Subject: UniStar Nuclear Energy, NRC Docket No. 52-016
Response to Request for Additional Information for the
Calvert Cliffs Nuclear Power Plant, Unit 3,
RAI No. 110, Offsite Power System

**Response to NRC Request for Additional Information
RAI No. 110,
Questions 08.02-1 and 08.02-2 and Questions 08.02-4 through 08.02-8,
Offsite Power System
Calvert Cliffs Nuclear Power Plant, Unit 3**

500kV TANGENT
CENTERLINE SPACING
MAX. STR. HEIGHT OF 130'

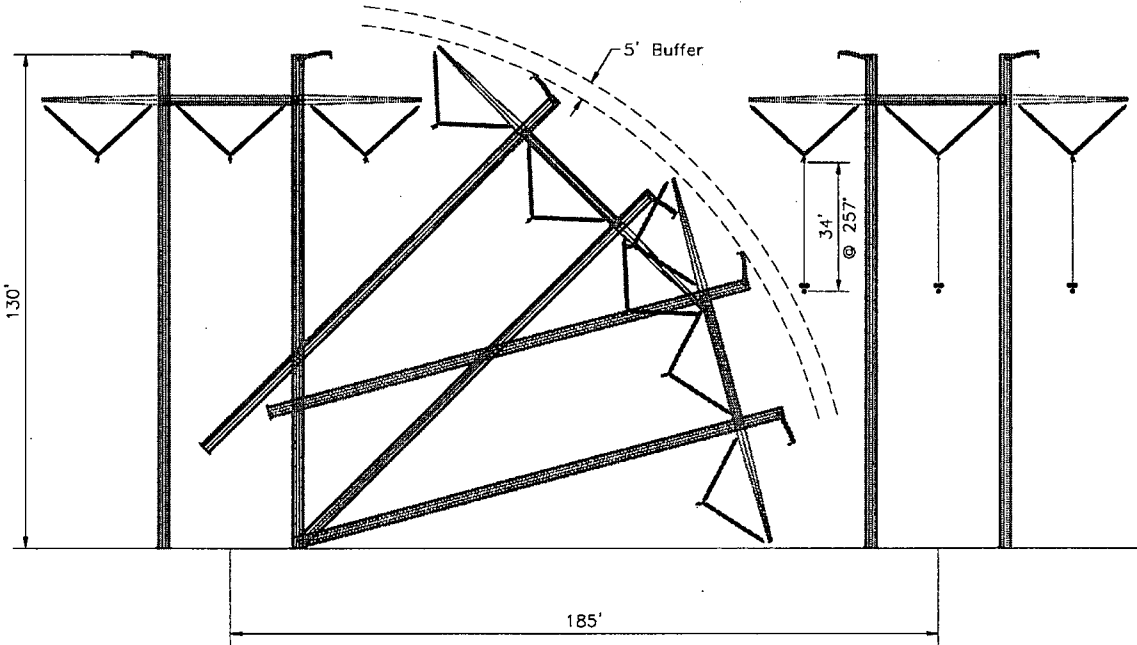
Section 8.2.1.1, page 8-11 of FSAR:

Indicates that the CCNPP3 design contains “four normally energized, physically independent transmission lines, designed and located to minimize the likelihood of their simultaneous failure under operating, postulated accident and postulated adverse environmental conditions including transmission line tower failure or transmission line breaking”. In view of this statement, the staff reviewed the 500 kV Switchyard and Transmission line Layout drawing 8.2-1. This drawing shows the four new overhead transmission lines are laid parallel in close proximity with each other on one right-of-way. The close parallel runs show apparent vulnerability to severe natural phenomena or weather events which can cause simultaneous failure such as tower collapse or line breaking. Address this staff concern and provide a highlight of the design bases for the SSCs to reflect appropriate consideration of the most severe of the historically reported natural phenomena. The applicant is requested to amplify their discussion of compliance with the requirements of GDC 2 and 4 to specifically address this concern. This discussion should confirm that the transmission tower separation, line installation, and clearances are consistent with the National Electric Safety Code (NESC).

The 500KV transmission line towers for the four lines originating from the CCNPP3 500KV Switchyard will be installed by Baltimore Gas and Electric (BGE) and spaced such that even if a tower collapses due to severe natural phenomena it cannot fall on the adjacent line or tower. A typical sketch of a falling tower indicating adequate clearance to adjacent lines is provided. This sketch indicates that there is no vulnerability of the 500KV Transmission Line Layout shown in FSAR Figure 8.2-1. Installation and clearances are consistent with the National Electric Safety Code.

CALVERT CLIFFS UNIT 3
 500KV SWITCHYARD
 TYPICAL PROTECTION SINGLE LINE
 FIGURE 1

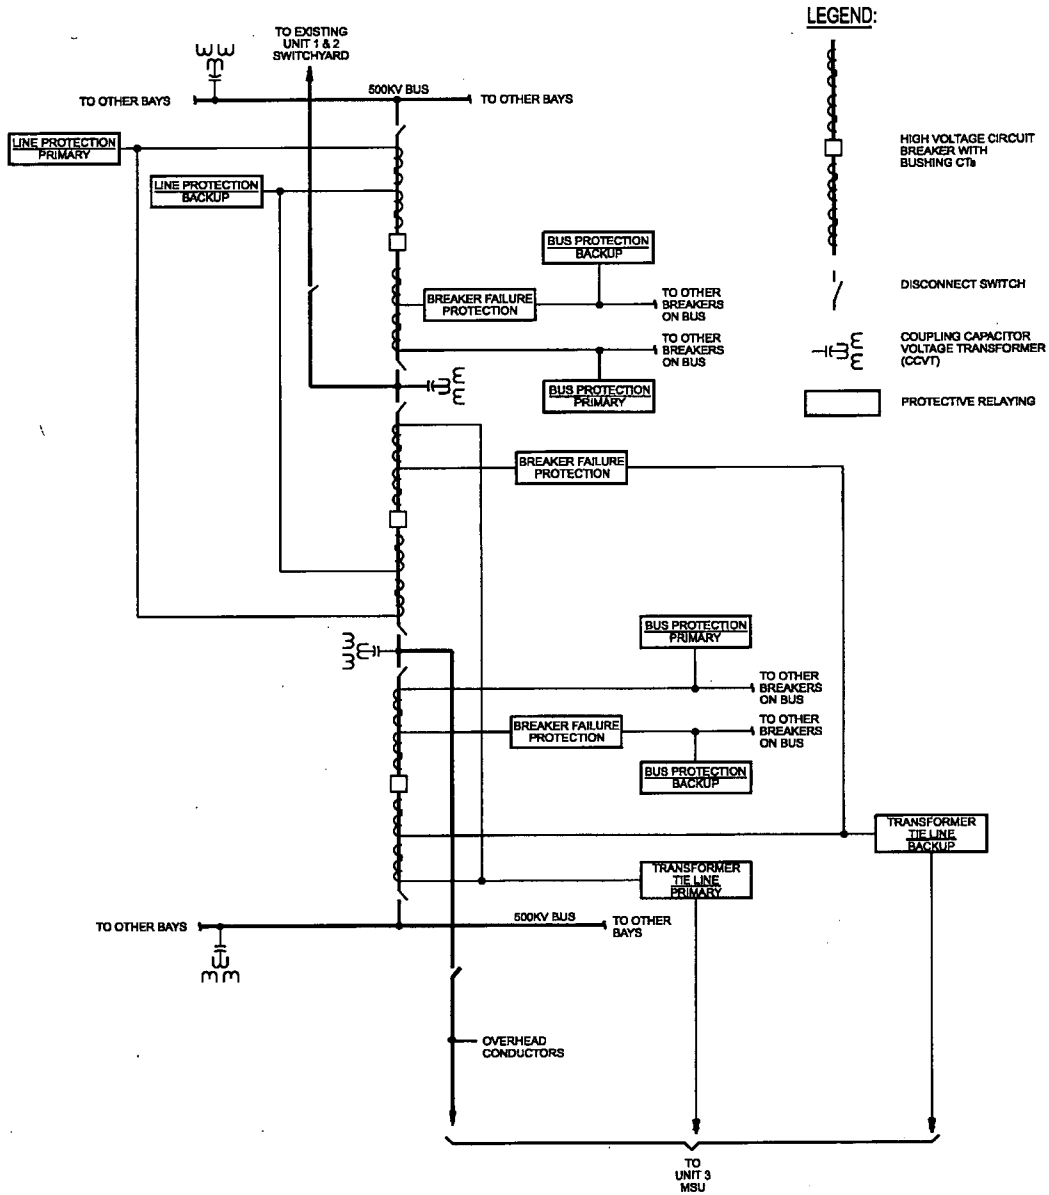
Section 8.2.2.4, page 8-20 of FSAR: 500 kV switchyard primary and secondary relaying system
- Provide a relay protection scheme/single line diagram for understanding of the primary and secondary protection scheme and zone of protection. Explain how the typical zone of protection will include main step up transformers, essential auxiliary transformers and normal auxiliary transformers.

COLA FSAR Subsection 8.2.2.4, page 8-18, provides under "Switchyard Failure Mode Evaluation", a section describing the breaker-and-a-half switchyard arrangement and the primary and secondary relay protection system. Attached Figures 1, 2, and 3 provide typical protection diagrams for the main step up transformers, essential auxiliary transformers and normal auxiliary transformers indicating overlapping protection zones. Each outgoing line to the grid is protected by redundant transmission line protection schemes. Each bus is protected by redundant bus differential protection. Each line between the switchyard and the plant transformers is protected by redundant tie line protection schemes. Each transformer is protected by redundant protection schemes. Faults within the transformers will trip the switchyard breakers to isolate the transformers.
